# BALLINA FLOOD RELIEF SCHEME PUBLIC CONSULTATION EVENT NO. 2

MGW0290  
Ballina Flood Relief Scheme Public  
Consultation Event No. 2  
S6.P01  
10 July 2023

**REPORT**

# Bunree/Behy Road Proposed Flood Defence

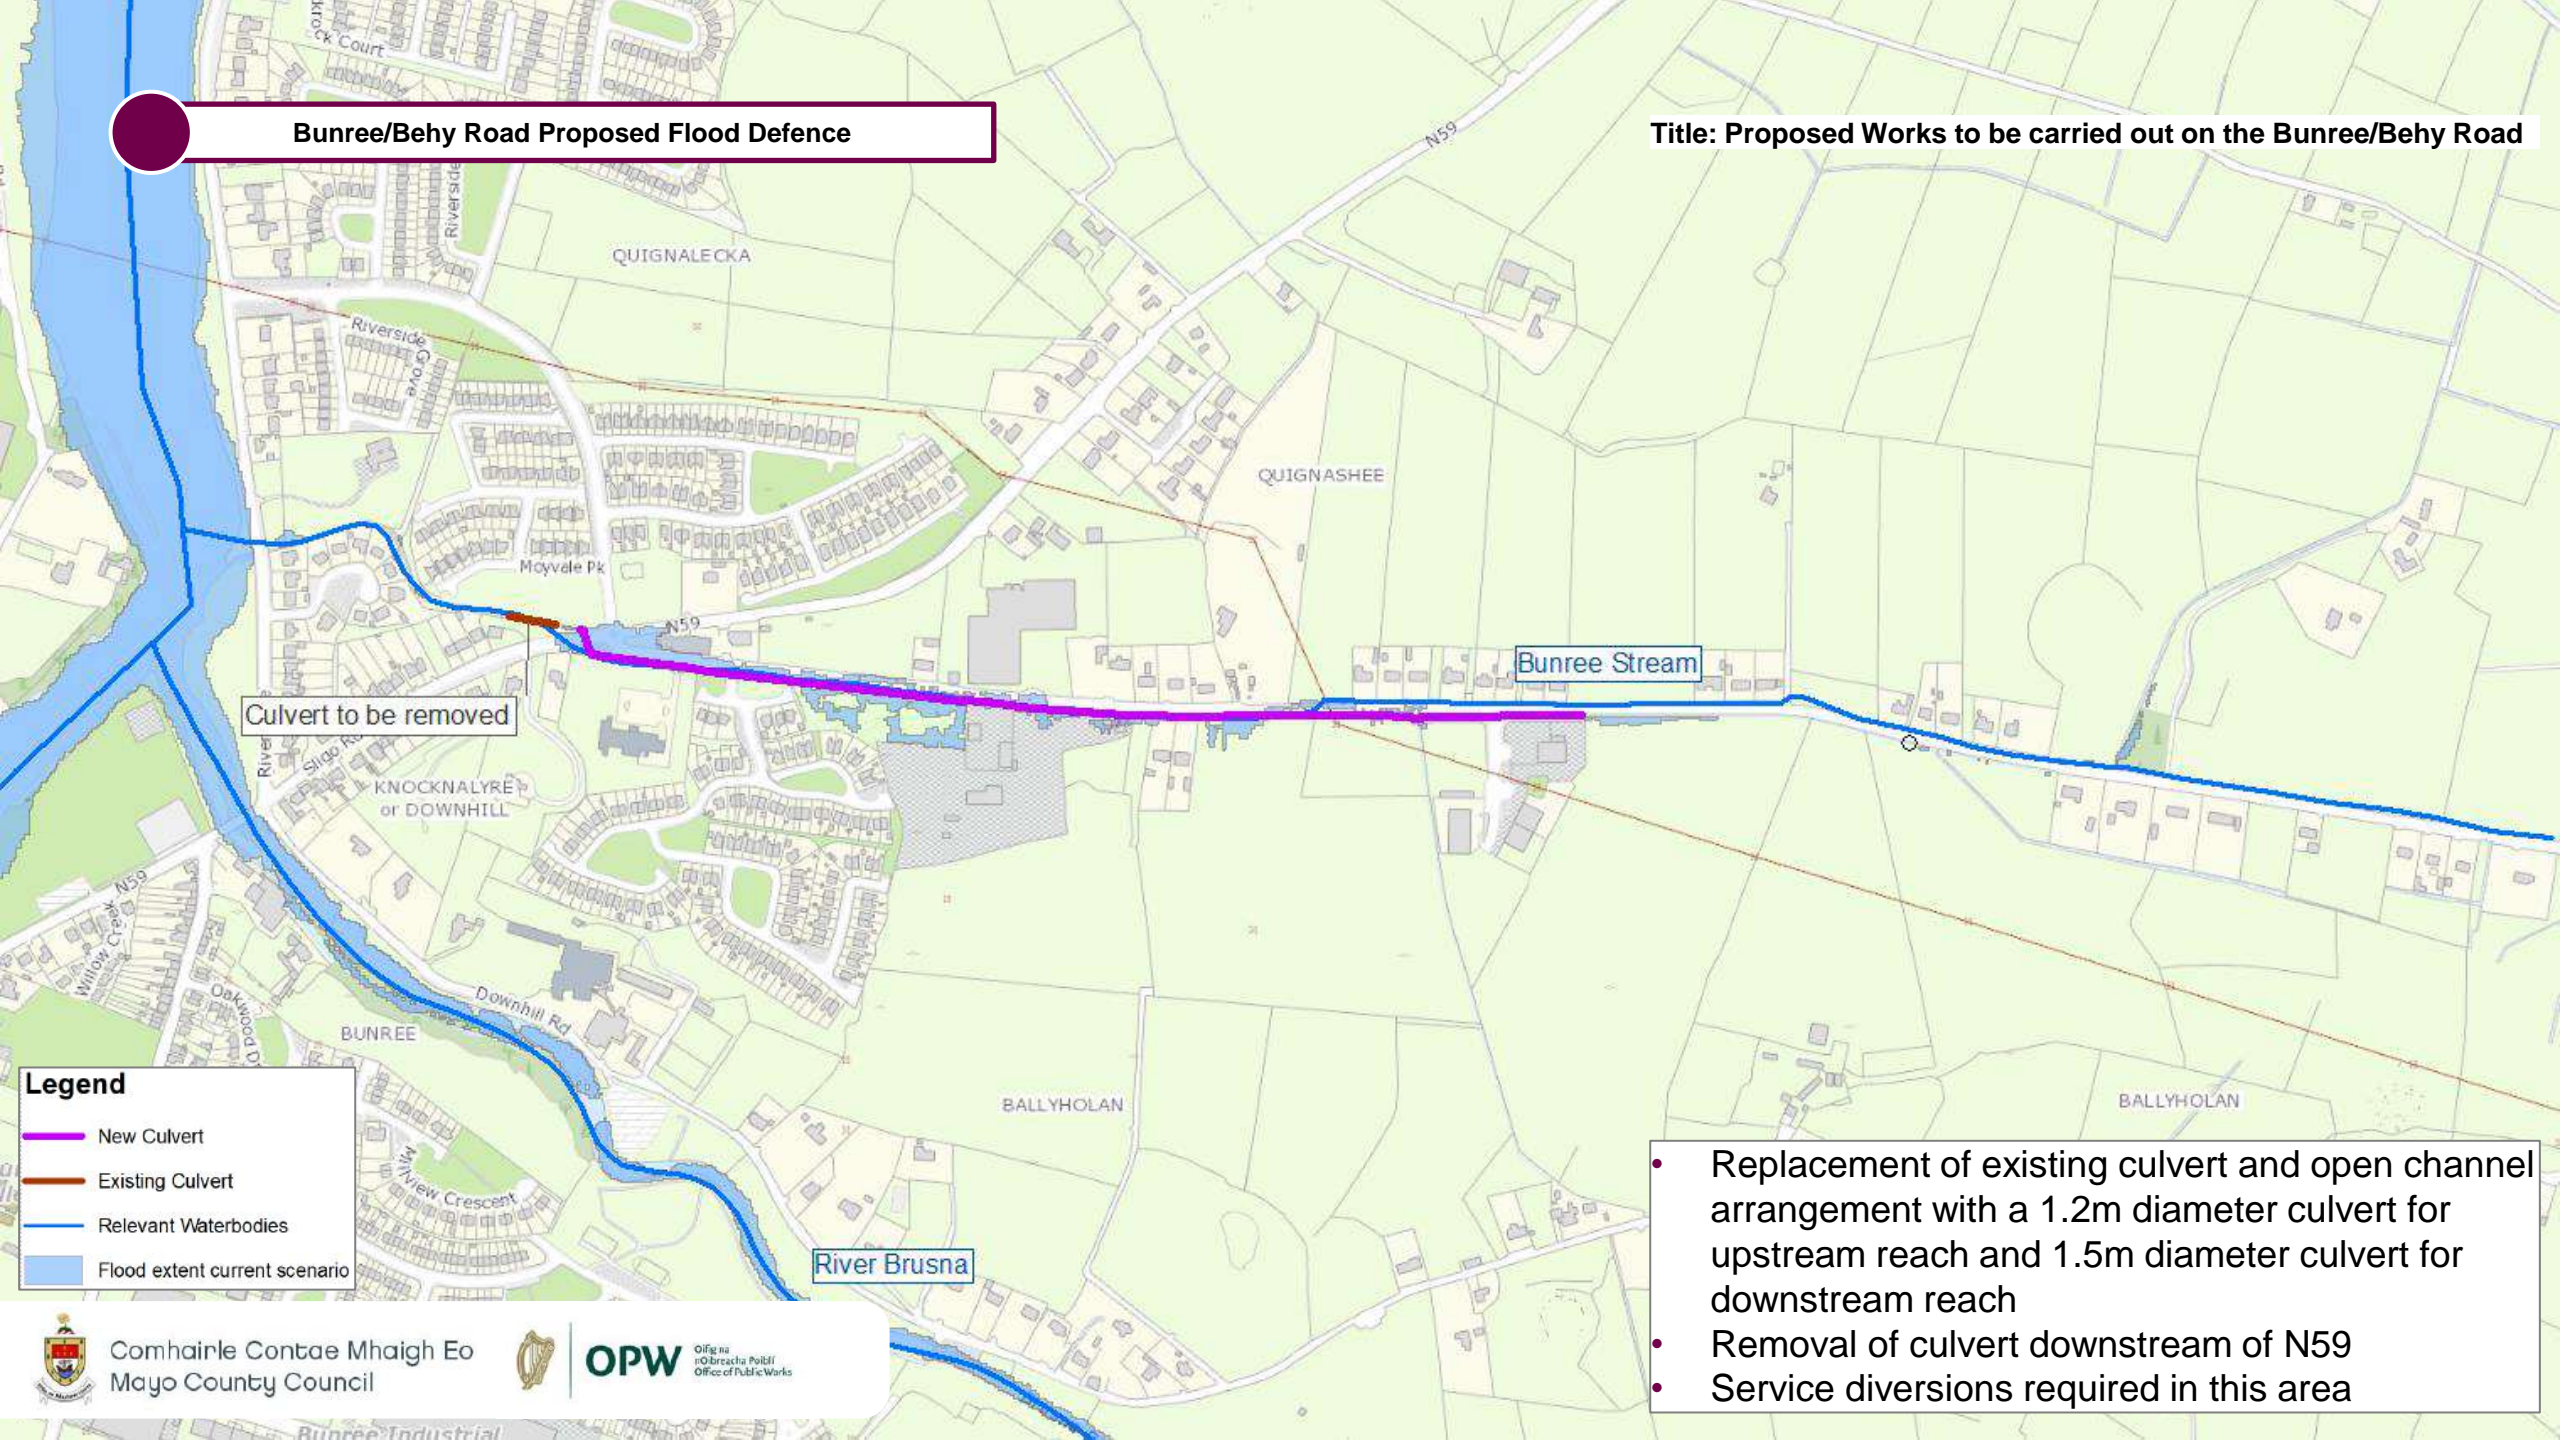
10. The physical structure of the Buree [sic] Stream has been significantly altered. IFI request that all exiting open channel is retained as open channel. The channel should be restructured to allow for conveyance or storage
-

of flood flows. This could be done by reprofiling the surrounding area to include a swale, floodplain or other nature-based solution.

## Brusna Proposed Flood Defences

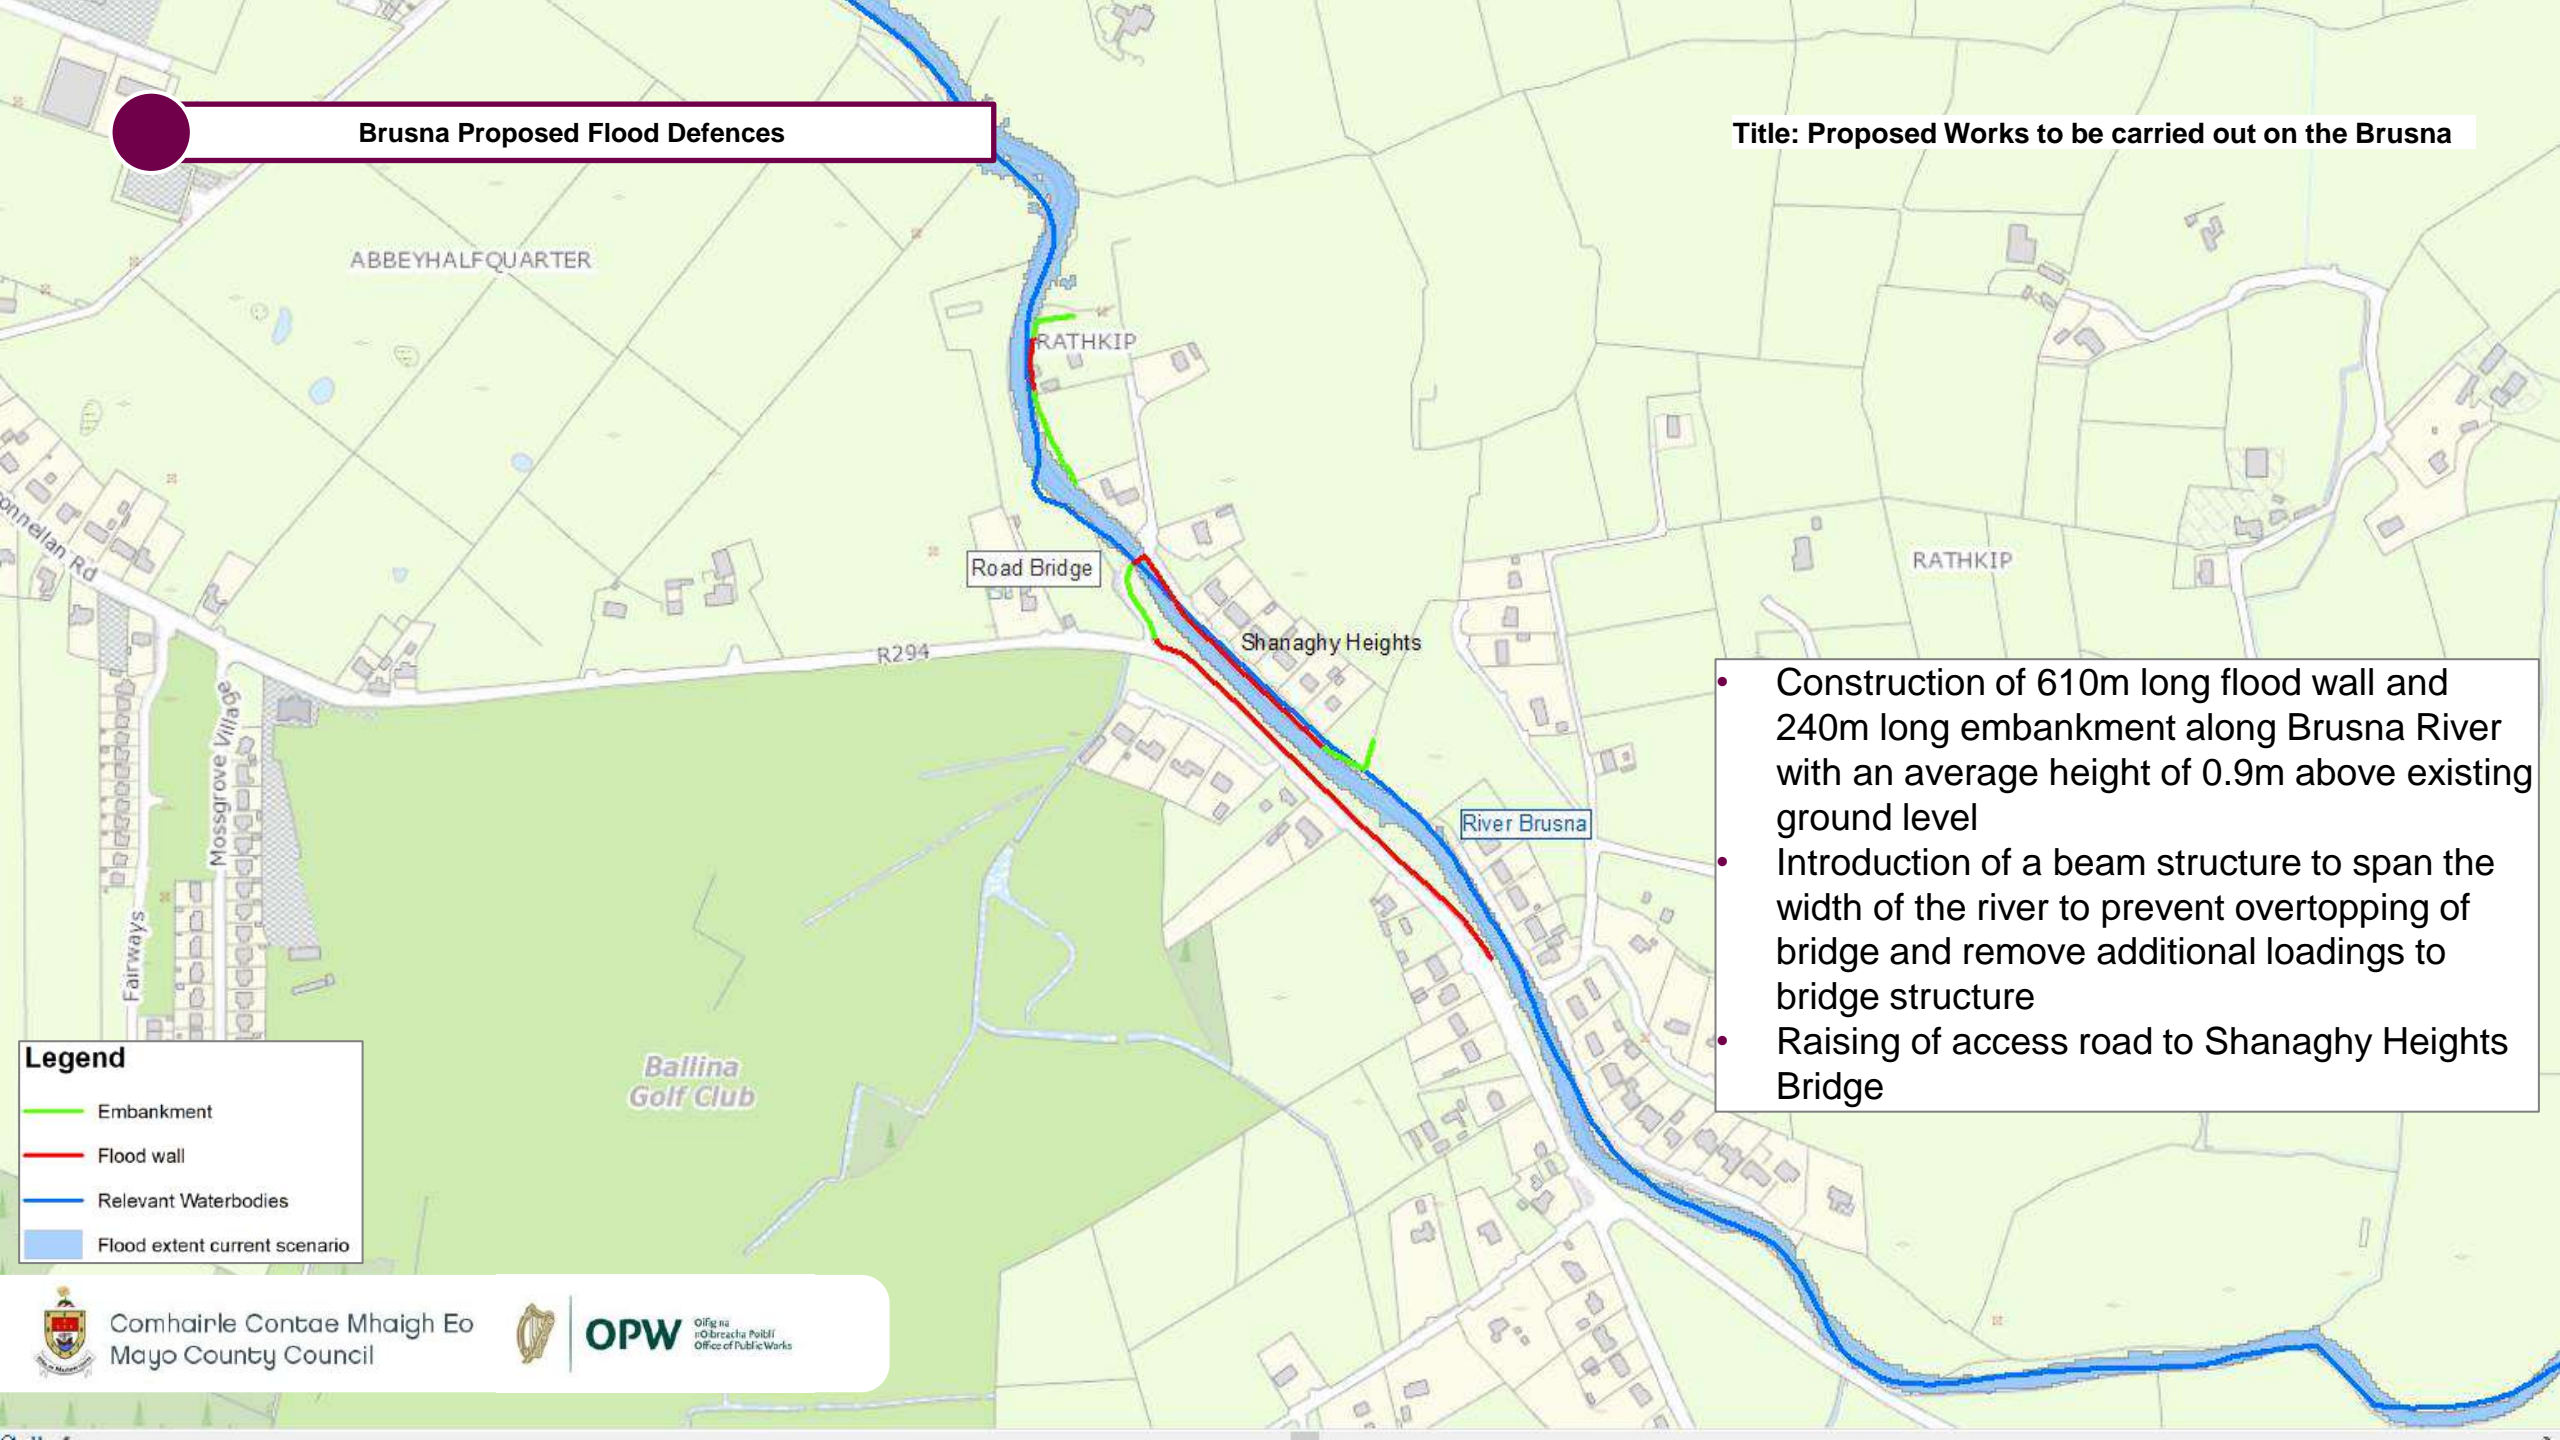
9. The Brusna River provides valuable salmon and trout spawning and nursery habitat. This catchment is under environmental pressure, salmon stocks have declined to below their conservations limit, that is the number of adult salmon returning to spawn required to support a sustainable fishery. As a result, this fishery is now closed to angling. This measure is in place to support the recovery of the fishery. The proposed embankment and flood wall is also within the River Moy Special Area of Conservation which is designated for the protection of Atlantic salmon, white-clawed crayfish and lamprey species. The placement of the proposed embankment and flood wall on the downstream bank should be moved back to allow for maximum connectivity between the river and the adjacent floodplain. All existing riparian trees and vegetation must be retained to protect biodiversity and mitigate high water temperatures.
